**ADDENDUM NO. 1**  
**May 21, 2026**  
**230693**

RE: **Charter Oaks Village Cooperative**  
**Arundel, ME**  
**Phase 1 Distribution Improvements**

FROM: DuBOIS & KING, INC.  
208 Union Avenue  
Laconia, NH 03246

**275-GALLON ABOVE-GROUND FUEL OIL TANK**  
NOT TO SCALE

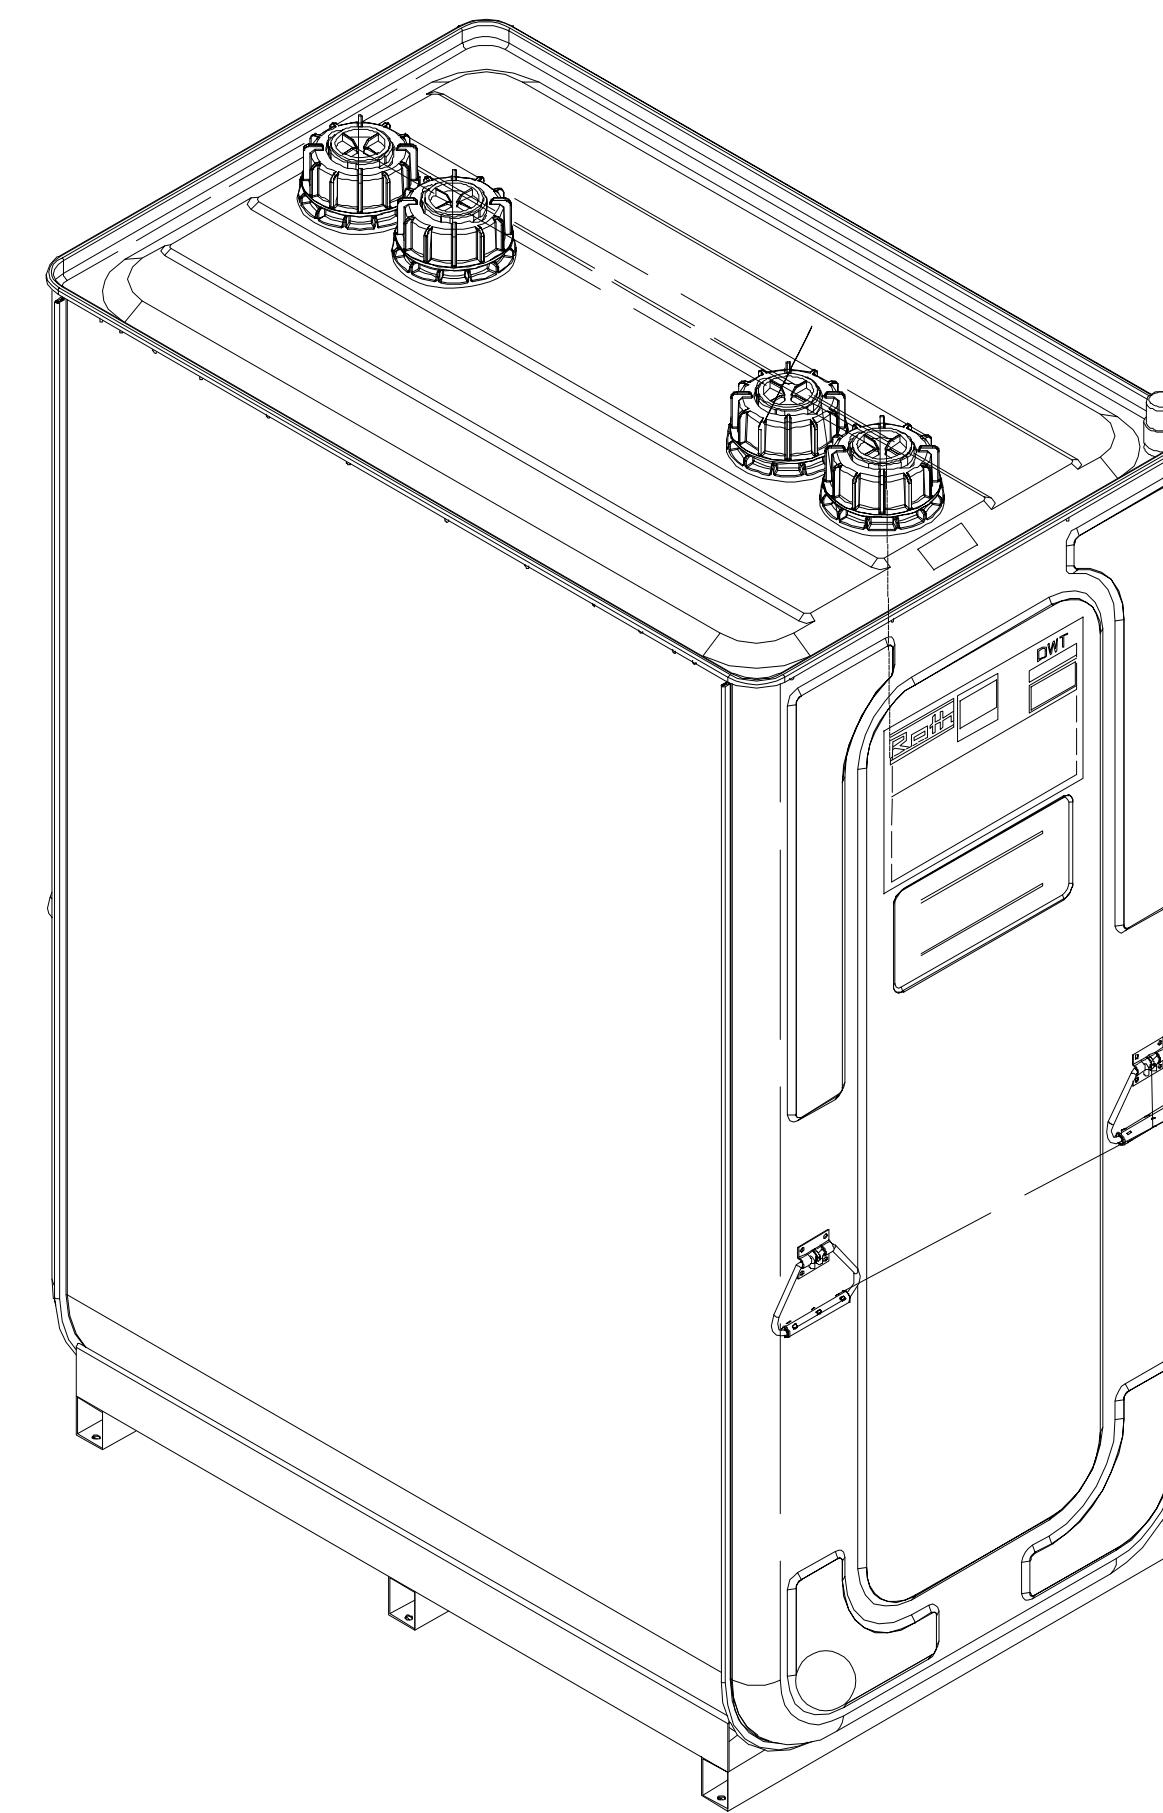
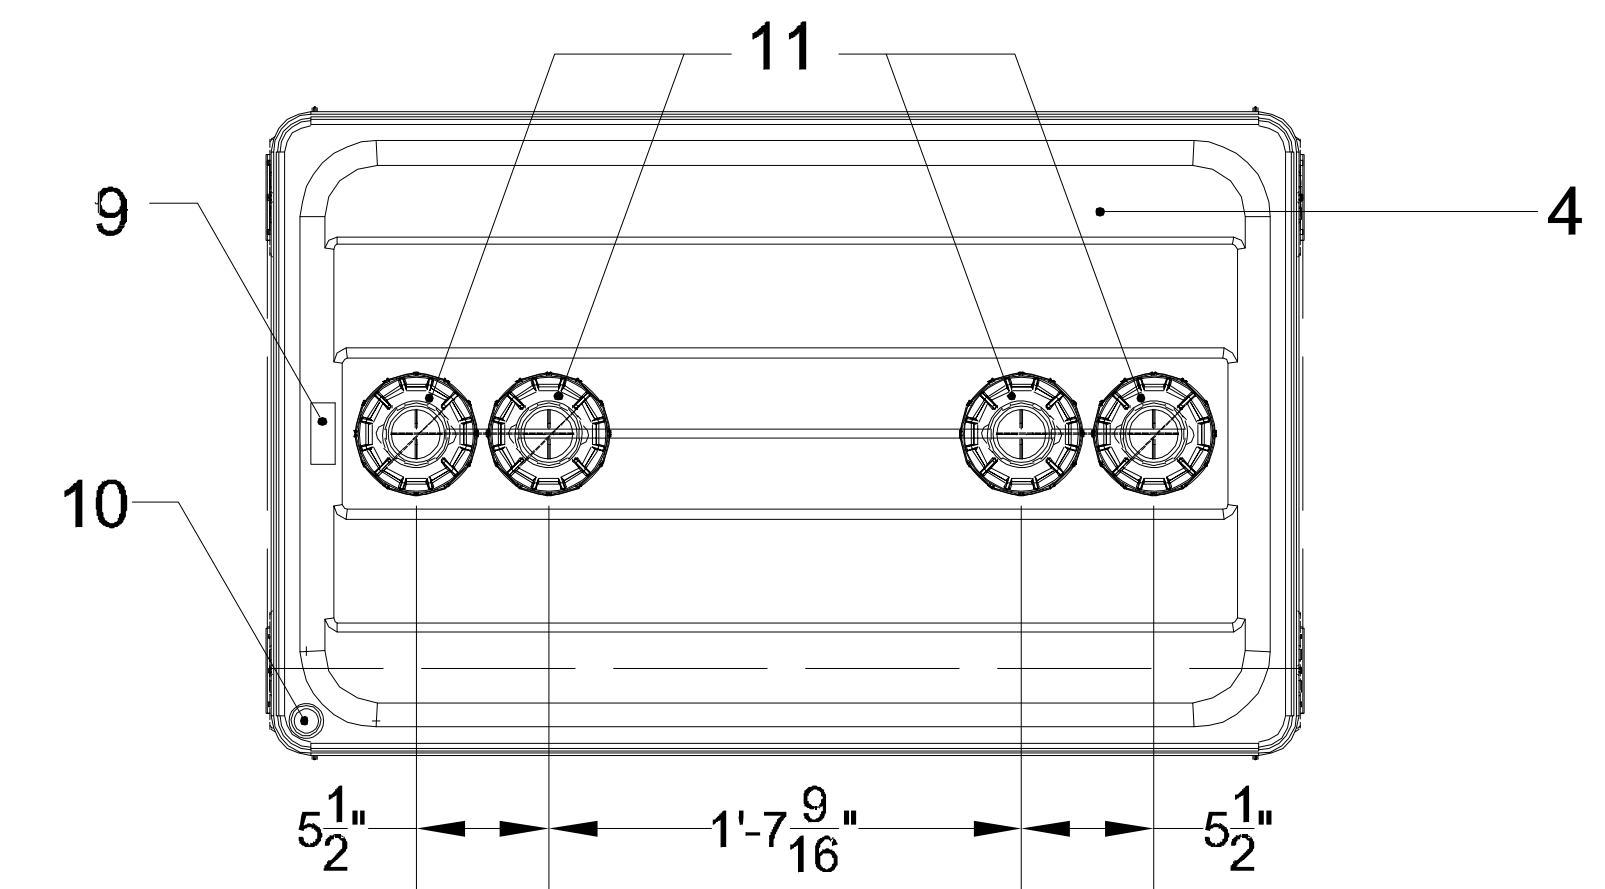
- New individual services were reconfigured to make it clear that no work is to be done under the home. (Sheet C2)
- A recently replaced septic system was added to the drawings as it is near a test pitting location and a connection point for the water main extension. (Sheets C3, C6)
- AST details were added to the plan set. (Sheet C10)

11. Question: What type and size tanks are specified? Can we provide a detail and/or pictures of the cover, concrete pad, and tank? Are the new tanks double-wall, 275-gallon capacity units? Do you have a unit (like a Roth tank) already onsite to look at, or can you provide a photo/spec of the required structures?
  - a. **Answer: A double-walled, 275-gallon above ground fuel oil storage tank. We have added details as Sheet C10. The standard is Roth DWT 1000L with cover or approved equal. Tanks shall be fully covered by a sturdy, well-constructed roof that meets or exceeds building code requirements for snow load and is constructed out of non-combustible materials. Tanks are to be installed on a 4-inch concrete pad at least 10% larger than the dimensions of the tank.**

| REVISIONS | DATE      | BY  | REVISION DESCRIPTION |
|-----------|-----------|-----|----------------------|
| 1         | 5/21/2026 | SAW | ADD SHEET TO BID SET |
